**SECTION 00 90 02
BIDDING AND CONTRACT REQUIREMENTS
ADDENDUM NUMBER 2**

Issued: May 5, 2026

**Fire Tower Replacement
Issued for Bid**

Architect's Project Number: 25-028

SHEET NUMBER:
S100

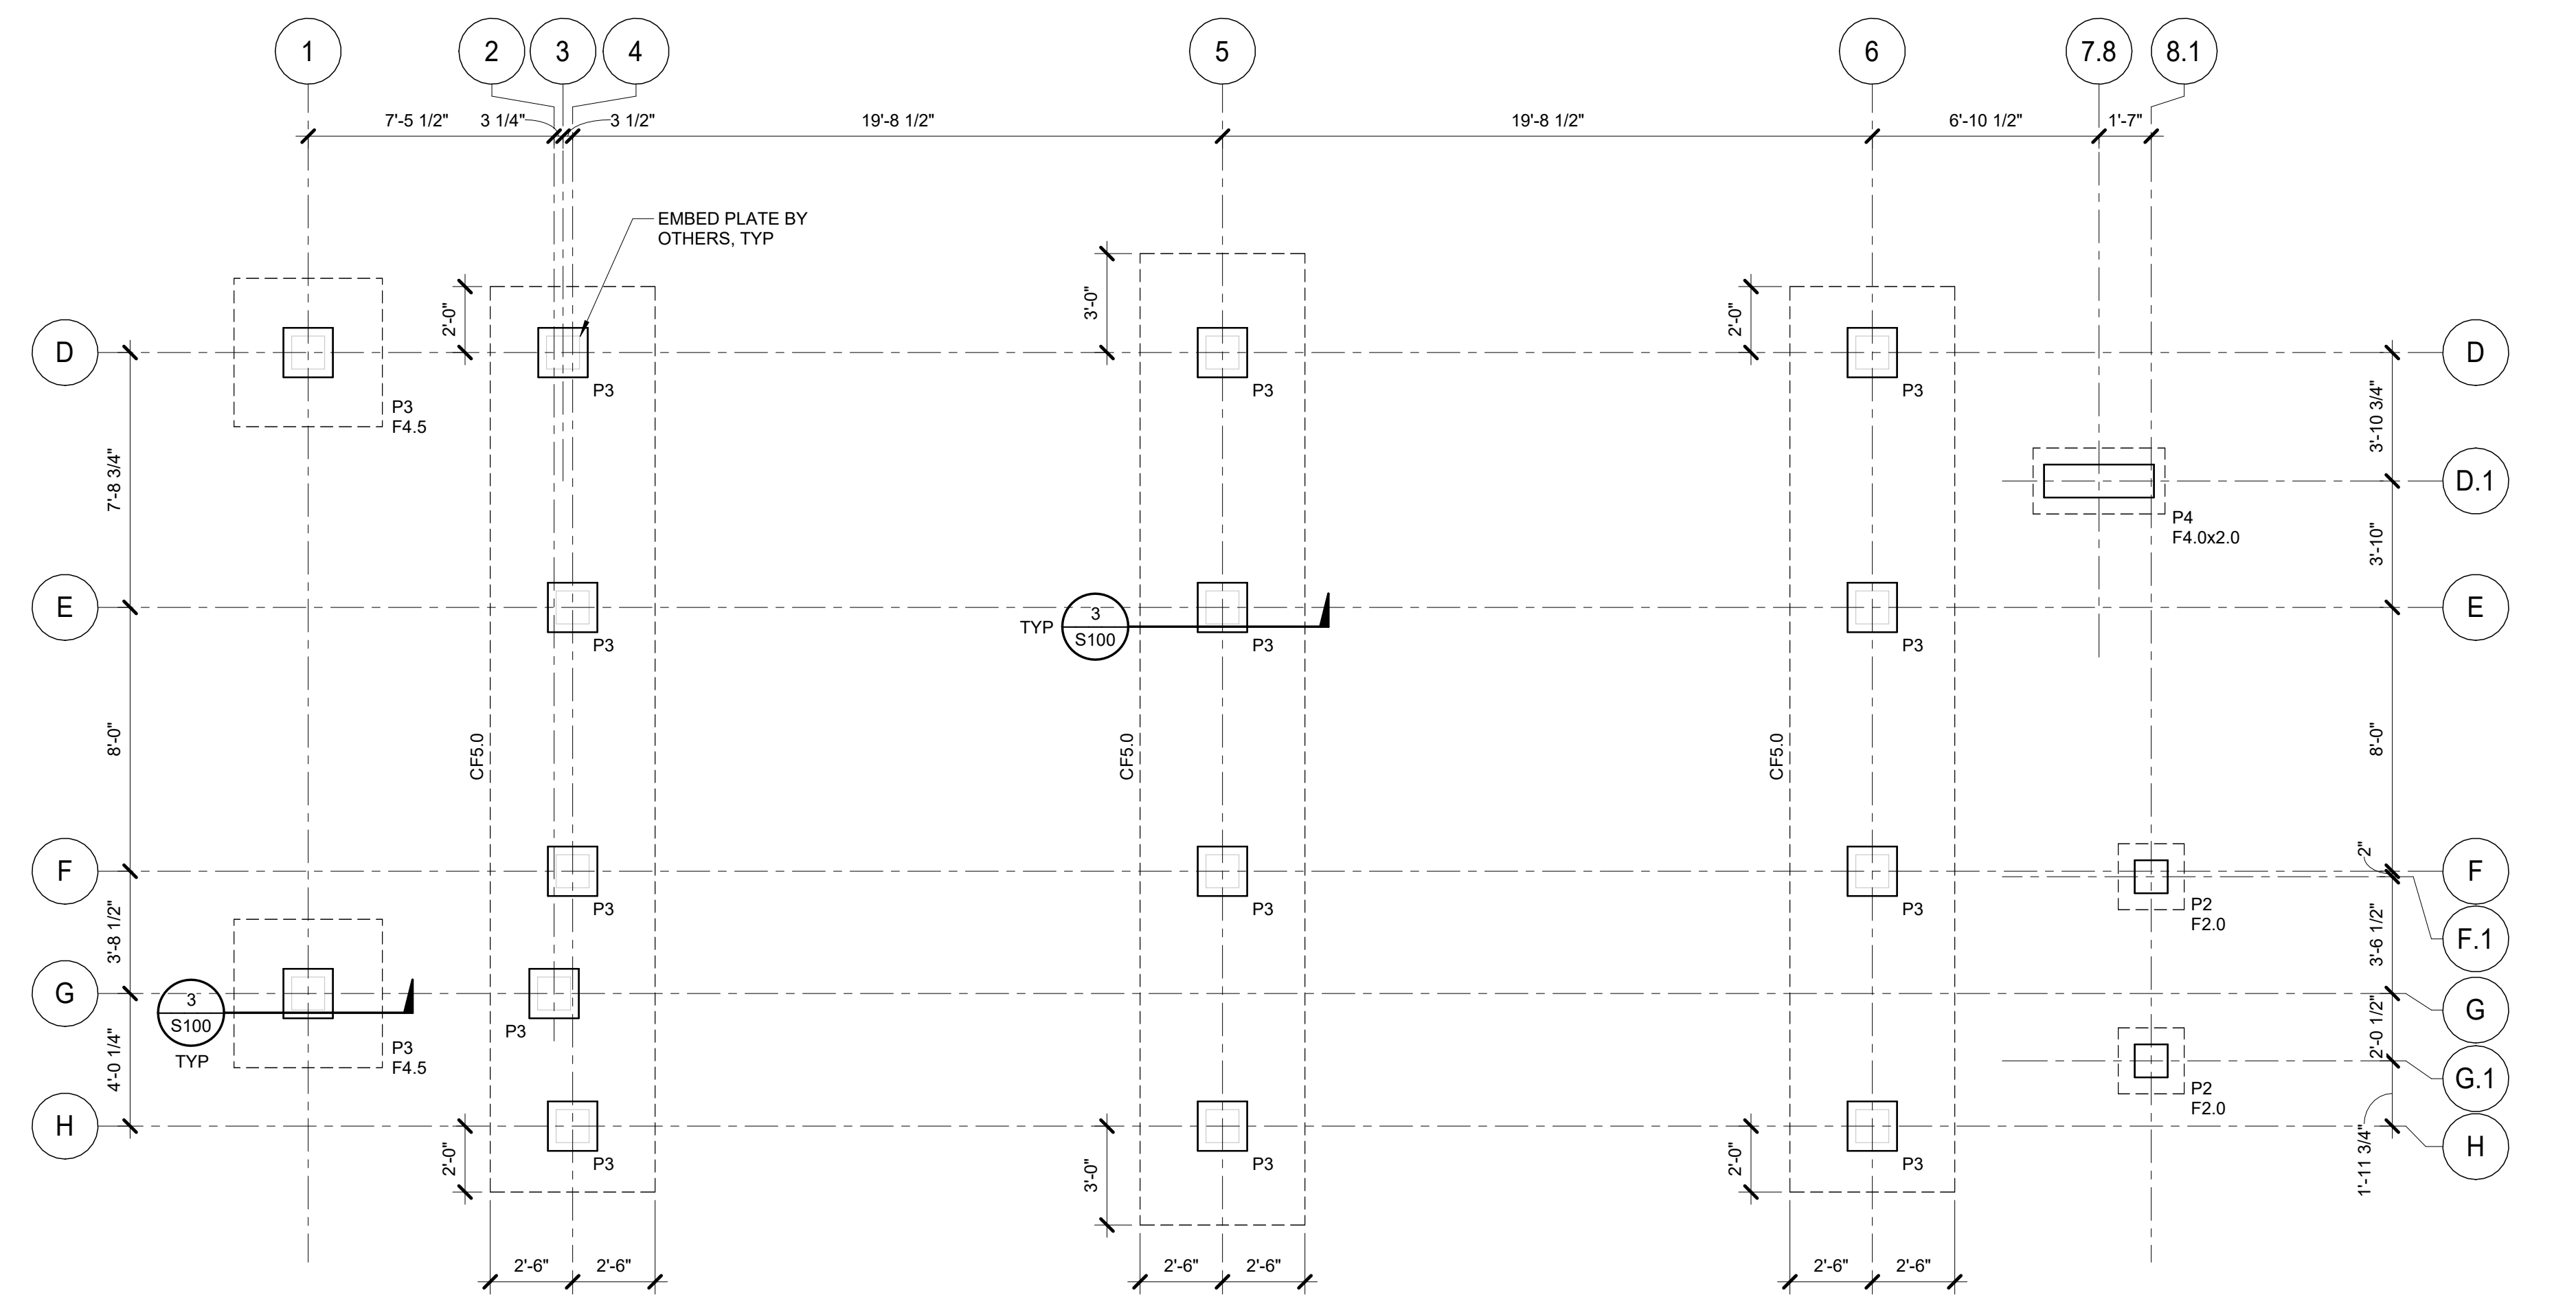
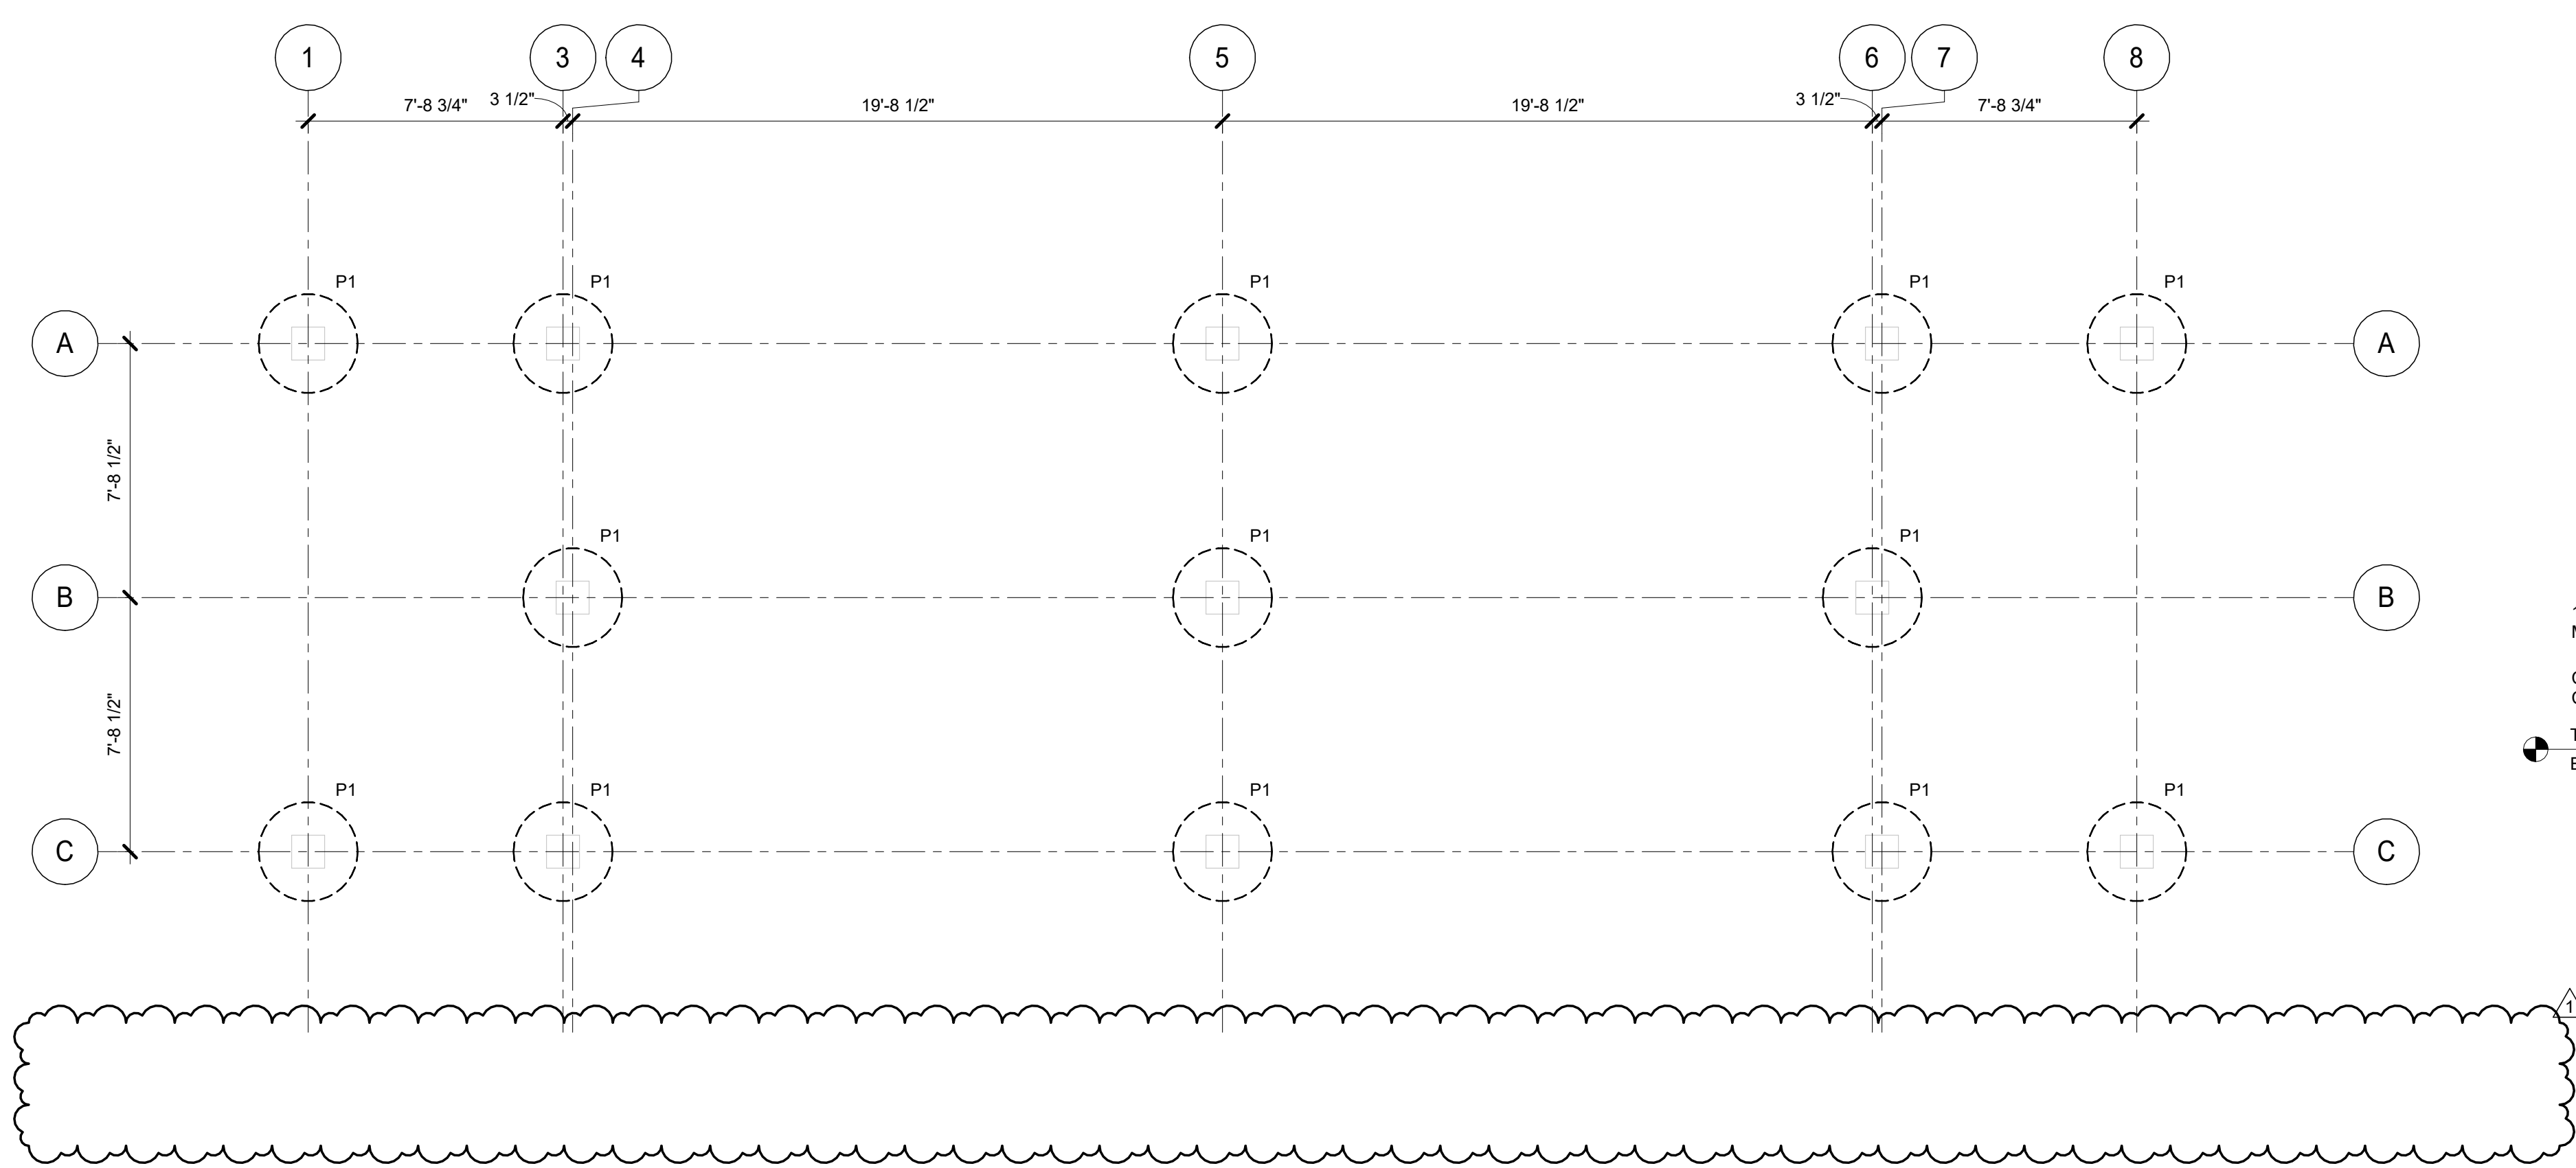
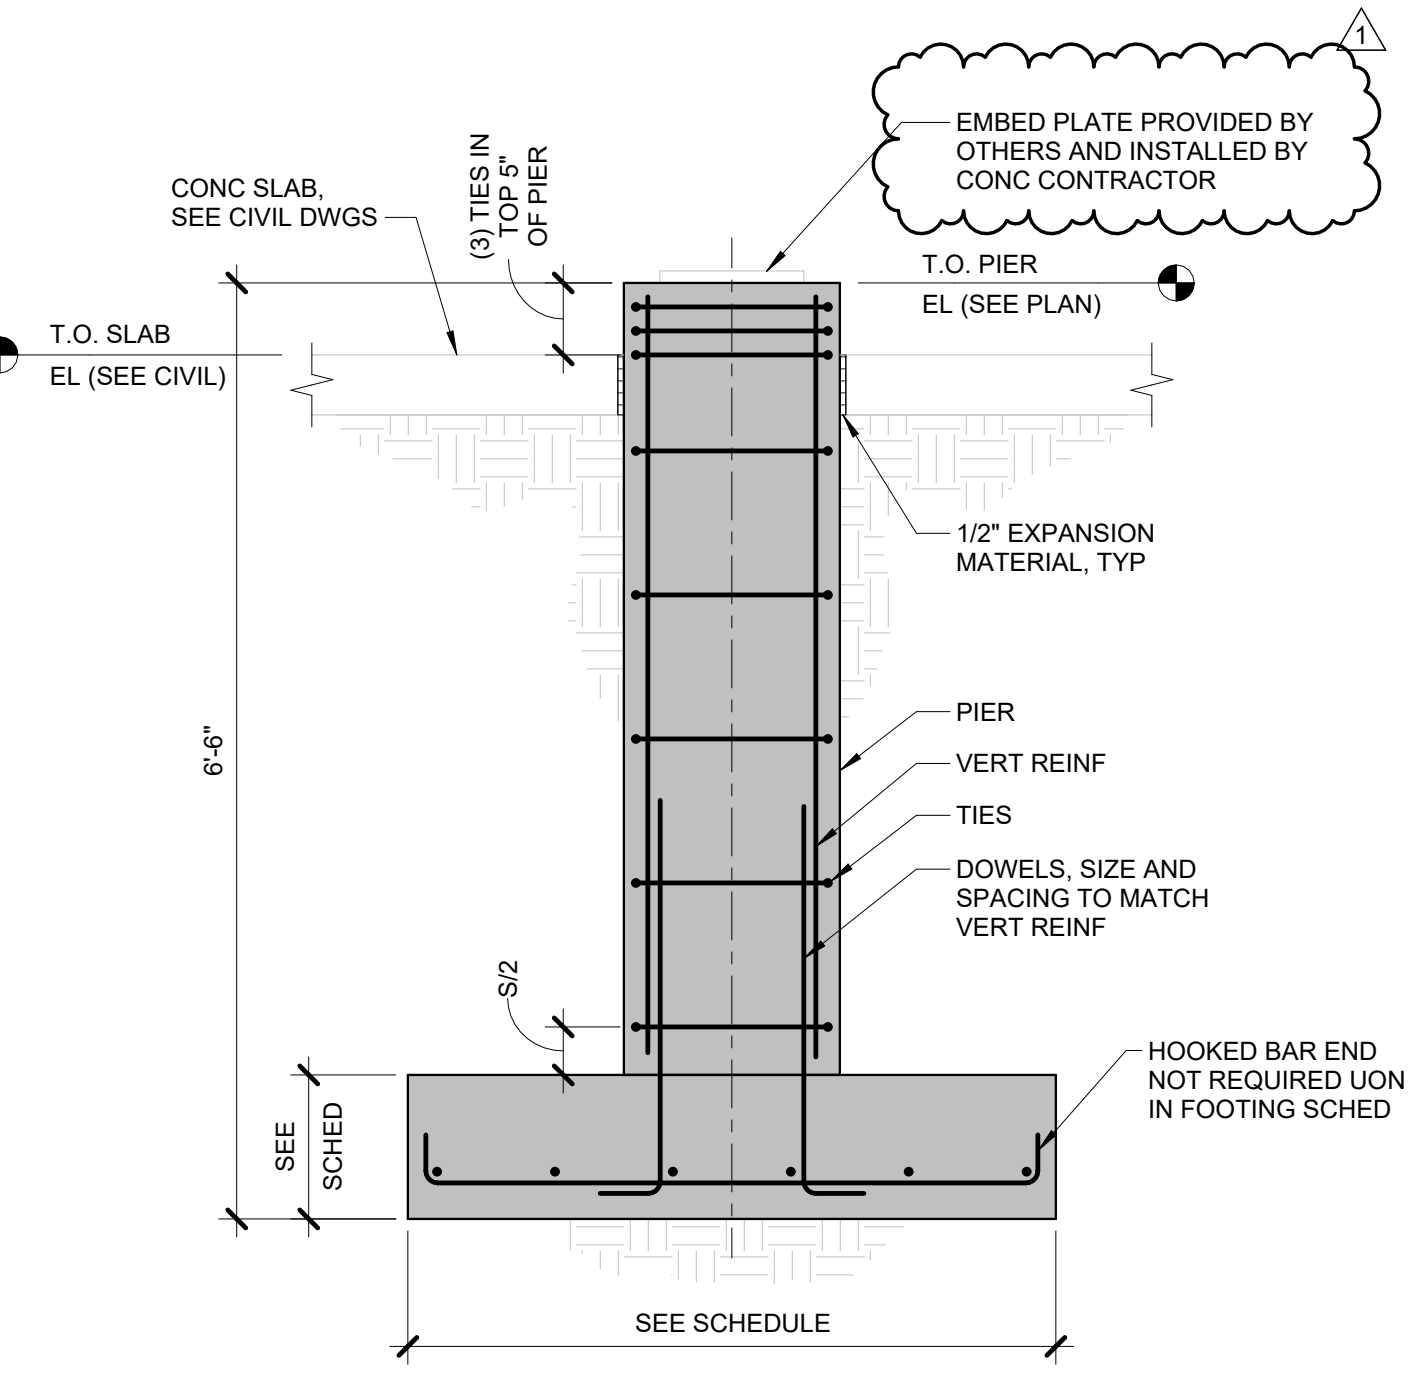
- A. **REVISE** embed plate notes in details 2 and 3 to clarify installation scope.
B. **REVISE** foundation plan column grids to show different grids at each building. Refer to civil drawings for each building location.
